**PROJECT : 0C2A**

**LTE NGFF/SIM**

Size	Document Number	Rev
	<b>USB 2.0/USB Charger</b>	2A
Date:	Tuesday, March 25, 2014	Sheet 3 of 4

## MultiMedia SIM (MNC)

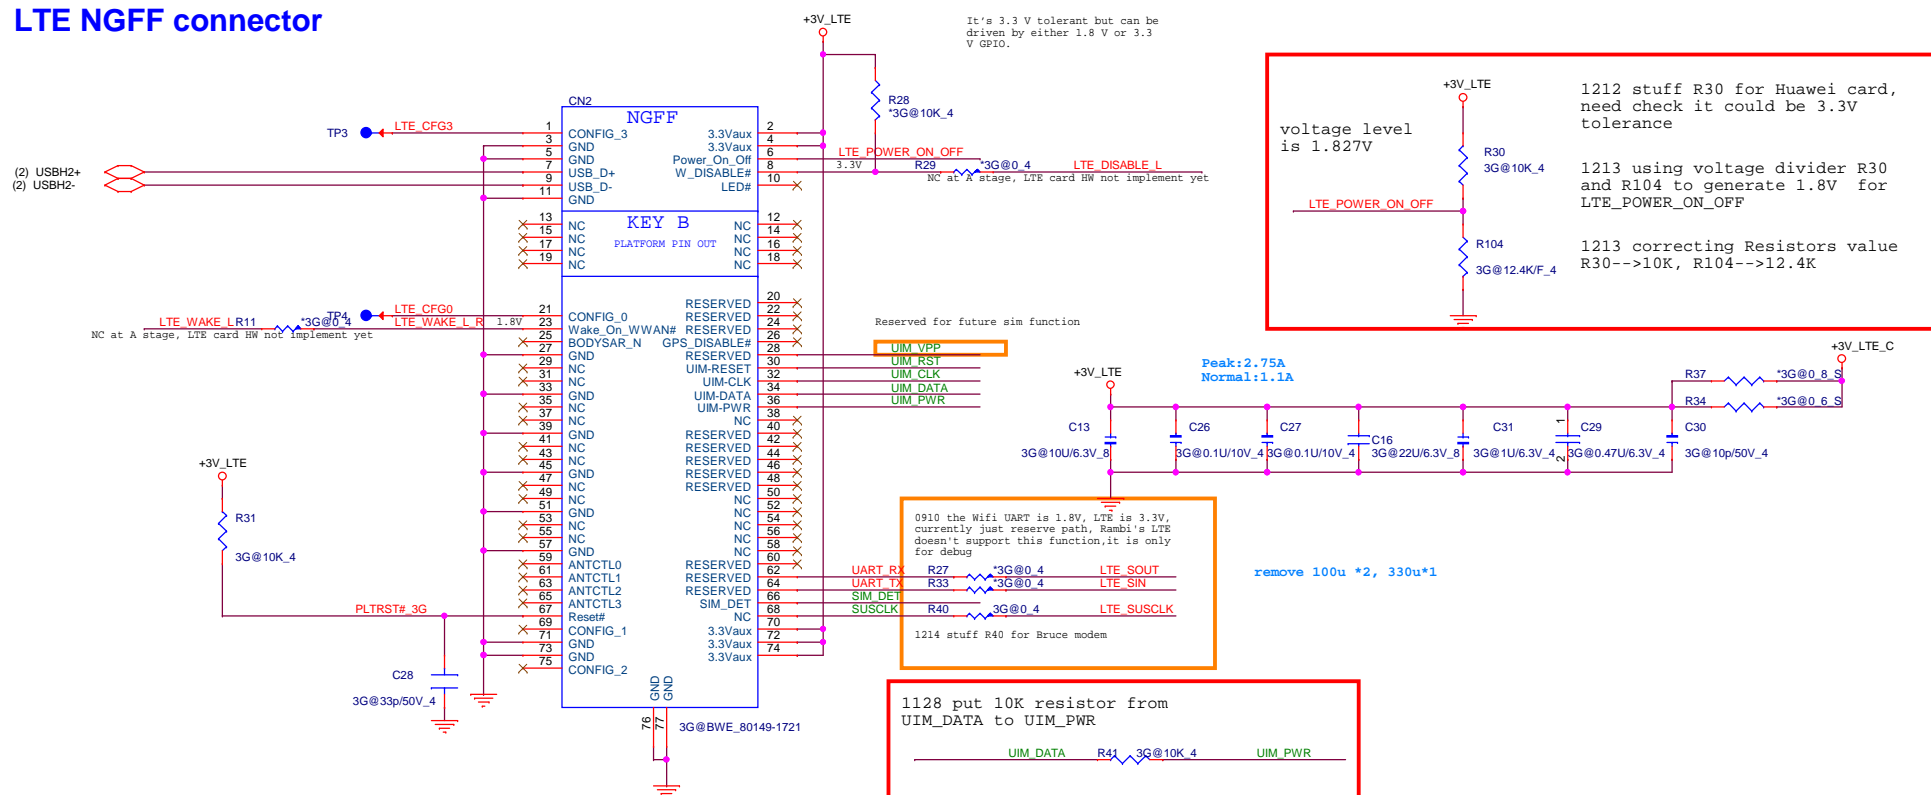
20140120 change SIM connector to 9pin DFHS09FR212

DFHS09FR212 is used in proto1 and 1.5, due to shortage issue, change to second source DFHS07FR047 which is no pin 4 and 8

## USB HUB

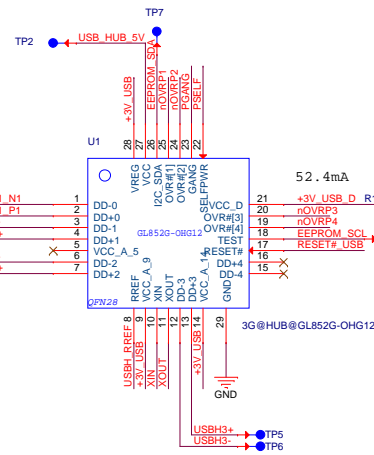
1021 3G@HUB@ means HUB will be stuffed if 3G/LTE exists

1021 If USB2 external IO has wake up feature, HUE  
power need to be available in S5 +3V USB
